TOWNSHIP OF GLOUCESTER

TO: Zoning Board of Adjustment
FROM: Kenneth D. Lechner, PP, AICP, Director/Planner
 Department of Community Development & Planning
RE: **APPLICATION #162039C**
John & Maryellen Gallen
212 Burleigh Drive
BLOCK 12807, LOT 1

DATE: June 21, 2016

The above application is to permit a 7' x11' concrete porch with roof overhang addition and within the R-3 Residential district as per the submitted sketch.

Roof System

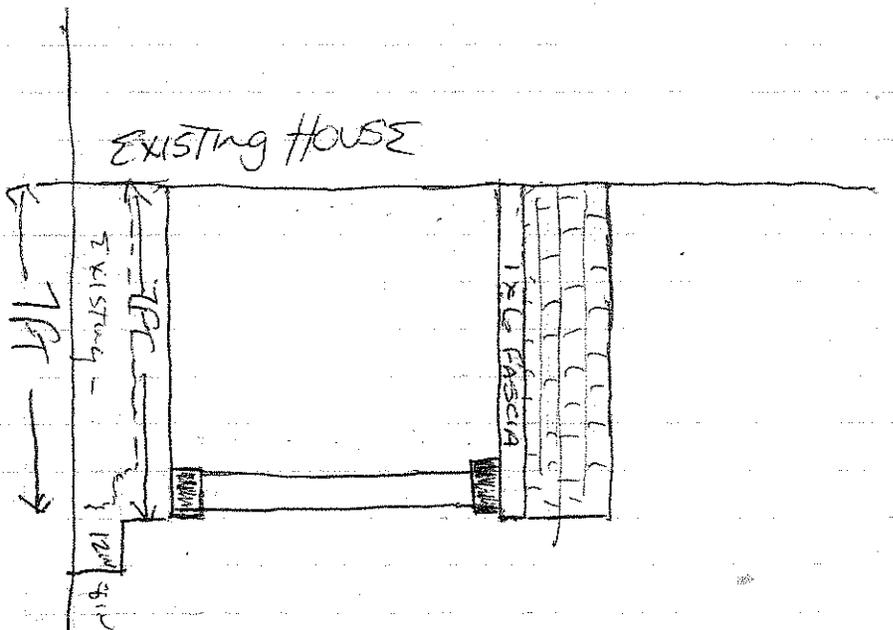
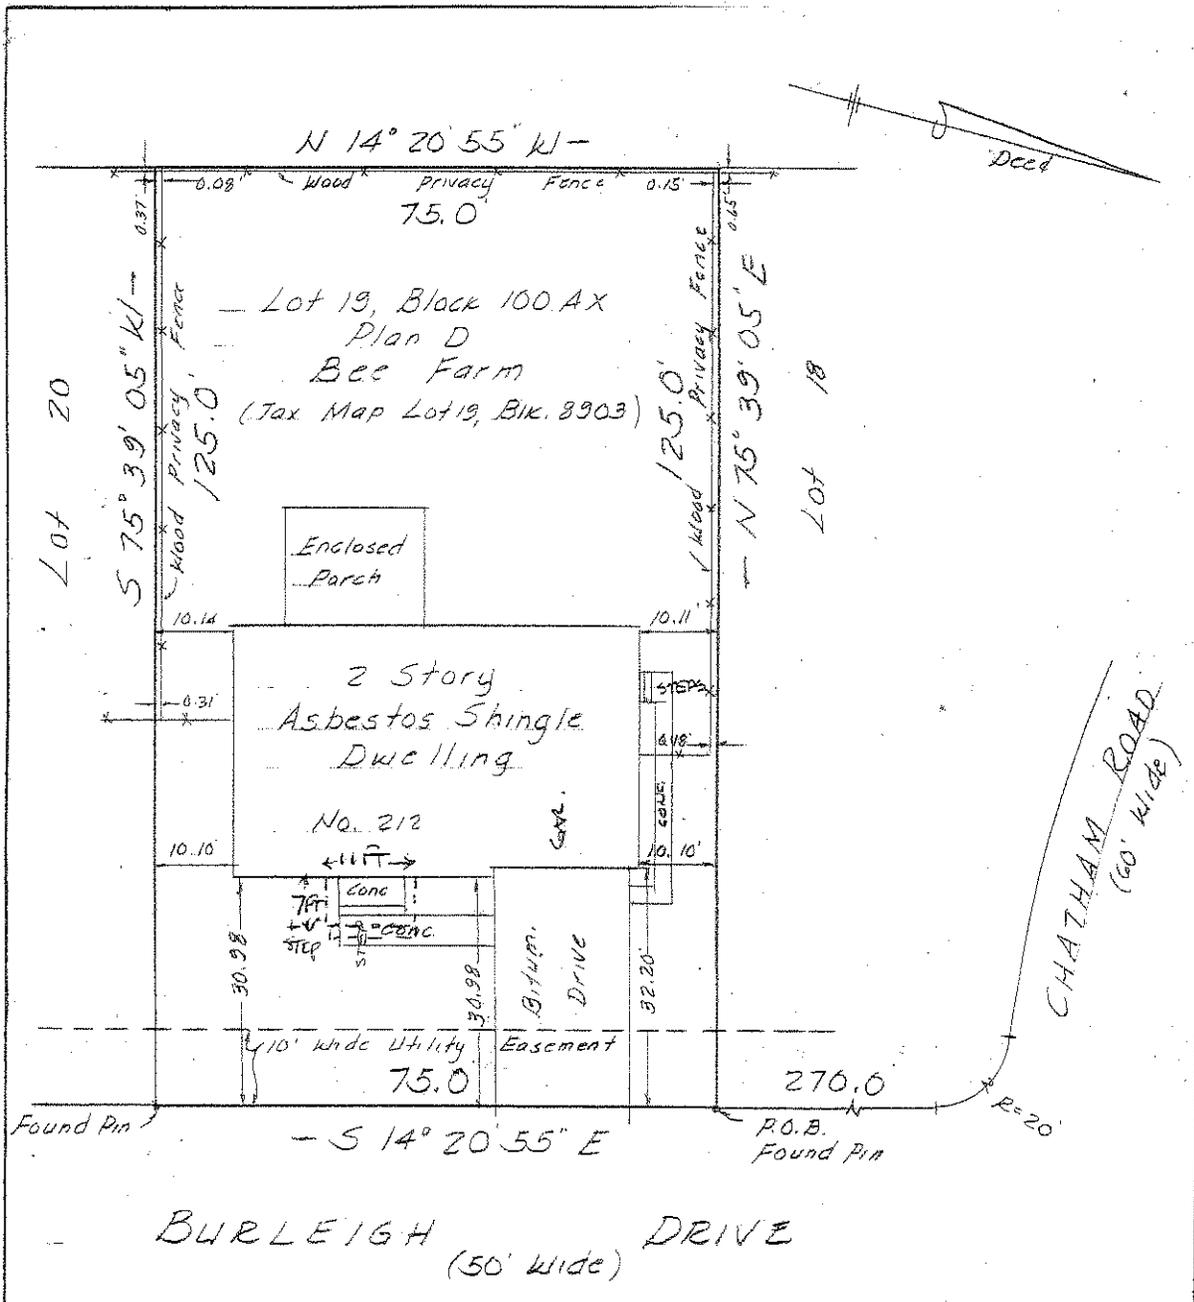
| <u>Standard</u> | <u>Required</u> | <u>Proposed</u> | <u>Complies</u> |
|--|-----------------|-------------------------|-----------------|
| Front yard (roof overhang) | 30 ft. | ±24 ft. | no* |

1. Building coverage: (±23% provided v. 20% maximum allowed).
2. Front yard: (±24 ft. provided v. 30 ft. minimum required).

Roof overhang encroaches within the 30' front yard setback. A Variance approval by the Zoning Board of Adjustment is required prior to issuance of permit.
